Meeting Agenda  
**Skokie Appearance Commission**  
Wednesday, October 25, 2023 at 7:30 P.M.  
Village of Skokie  
5127 Oakton Street  
Skokie, IL 60077

<b>2022-067A – 4600 Main St.</b> Applicant: Arie Crown Hebrew Day School Owner: Luz & Associates #1LLC Request: New Residential Development
--
- V. **Public Comment (for non-agenda items)**
- VI. **Adjourn**

### **Case 2022-067A- 4600 Main St- New Residential Development**

**SUBJECT: APPEARANCE COMMISSION STAFF REPORT**

Scheme 1 - Building Elevations

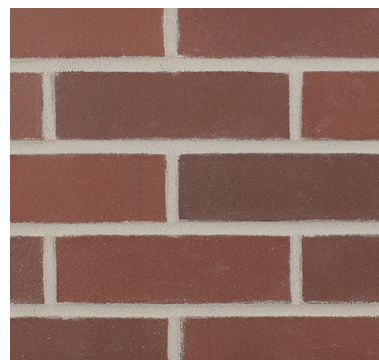
Chairman Lynk is unsure about the amount of white cement board.

Commissioner Maschek said the fiber cement stands out. He said that traditional or contemporary in design are options but that it should not be both. He added that conformity with surrounding structures should not be done at the expense of quality.

Chairman Lynk said that the cement board makes it look 'cheap'.

Commissioner Maschek asked Staff to project the design that features gables and bump outs. The Commissioner compares the two designs. He stated that more brick should be added and that he does not like the dog house-like roofs.

Chairman Lynk requested that the project be re-presented to include all brick elevation, brick element to replace white board area, varying color of lighter color cement board or improved rendering, continuous canopies, soffit or feature above upper window, cut sheet of proposed fence and windows on side elevations.

The architect said there is no objection to going to all brick façade and removing white cement panels. Relief is being asked on this between the 2 story windows.

**2022-067A 4600 Main St** – Staff has no objections to the updated elevations and fencing detail. The elevations appear to have addressed the Commissioners concerns that were brought up at the October 11<sup>th</sup> meeting. As a reminder any lighting from the site must not spill over to abutting properties. Staff recommends approval as presented
